RADIATION EXPOSURE DUE TO VENTING TMI-2  
REACTOR BUILDING ATMOSPHERE

A Study Prepared by the Institute for Energy and  
Environmental Research, Heidelberg,<sup>\*)</sup> Federal Republic  
of Germany for the Three Mile Island Legal Fund,  
Washington, D.C.

Bernd Franke and Dieter Teufel

Heidelberg, June 12, 1980

Figure 1: Comparison of Atmospheric Dispersion Factor Calculated with Data Sets from Different Authors  
 (from: Bussian et al., 1980)

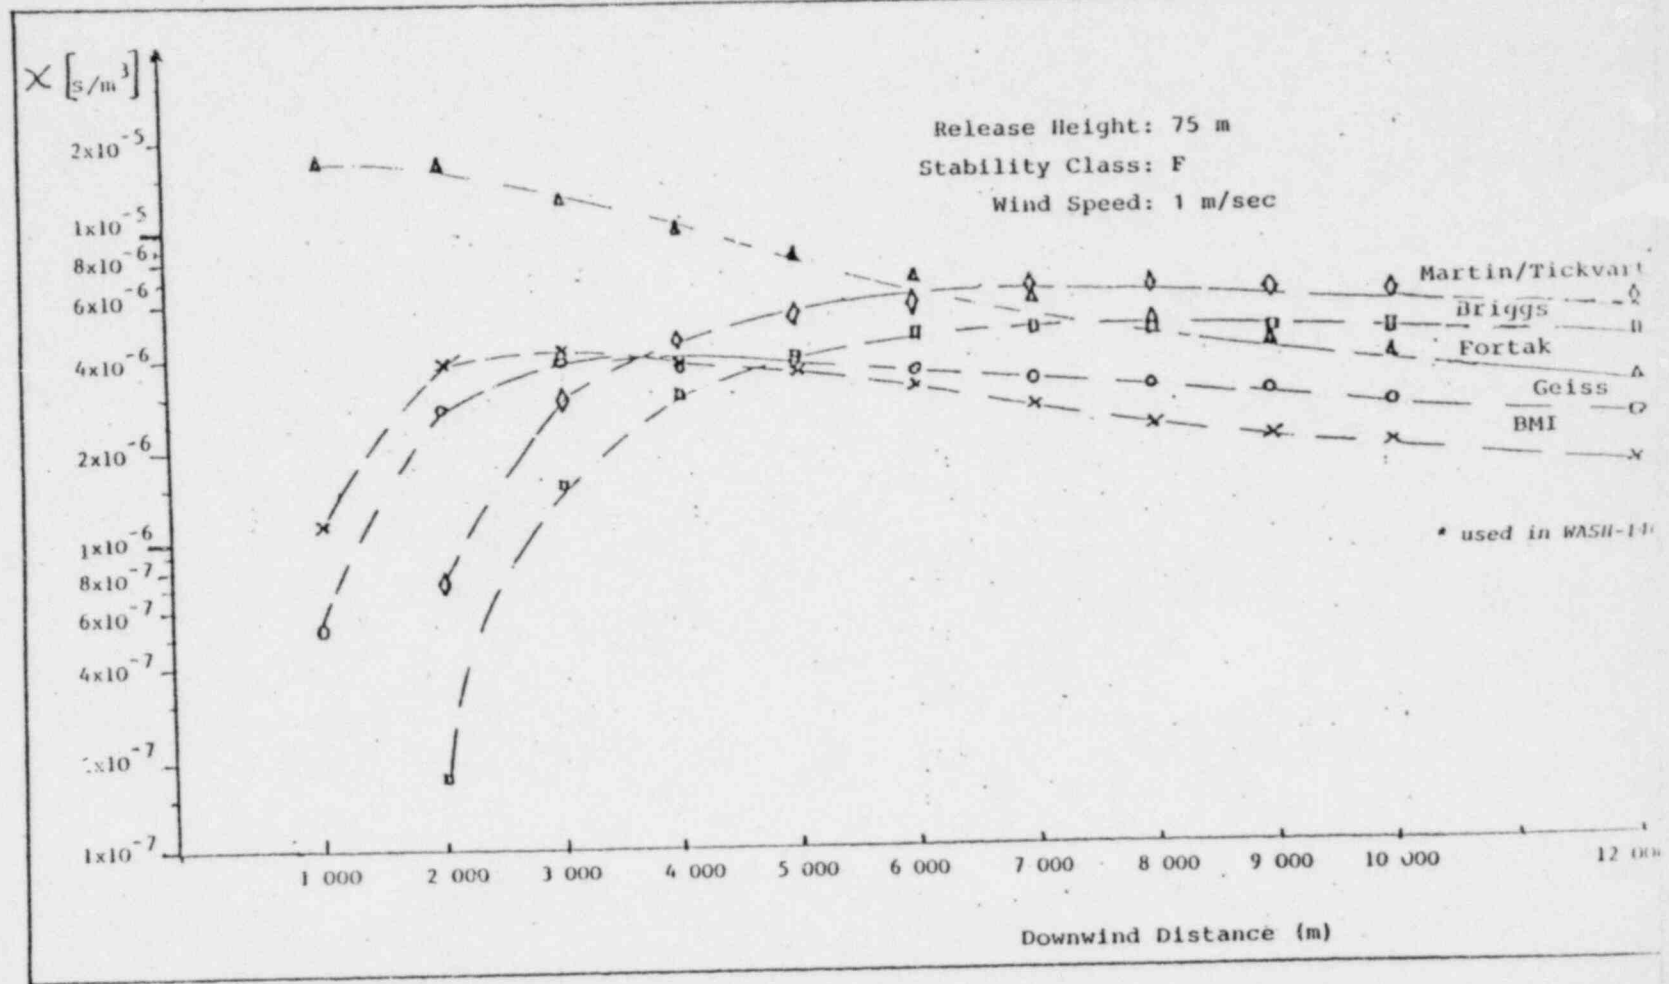
the meteorological dispersion factor  $\chi$  is computed in dependence of stability classes, wind speed and release height. However, it is clear that the data set used by Met Ed is not the only one available. Figure 1 shows the variation of meteorological dispersion as a function of the distance for a special weather situation and for certain distance from the emission source. When comparing the data sets from five different authors, we find a factor higher than 100 for  $\chi$  at 1 000 m downwind. For other meteorological situations, a smaller variation is found. Since each data set presents mean values originally derived from several measurements, there is an additional uncertainty of up to one order of magnitude. Therefore, the question of data sets is in fact highly relevant to whether or not Met Ed only releases under favourable weather conditions. We found that under all weather conditions Met Ed calculations may underestimate actual doses up to more than one order of magnitude.

The meteorological program proposed by Met Ed should ensure that environmental doses do not exceed the 10 mrem-limit skin dose. They do not, however, take the uncertainties described into account.

A more extensive investigation is necessary to eliminate these uncertainties and to give precise information about combination of meteorological parameters, under which beta skin doses of more than 10 mrem could be eliminated with low probability of error. With the present meteorological models and dose calculations, there are considerable doubts that the proposed venting program can exclude the possibility of individual skin doses due to Kr 85 exceeding the 10 mrem limit.
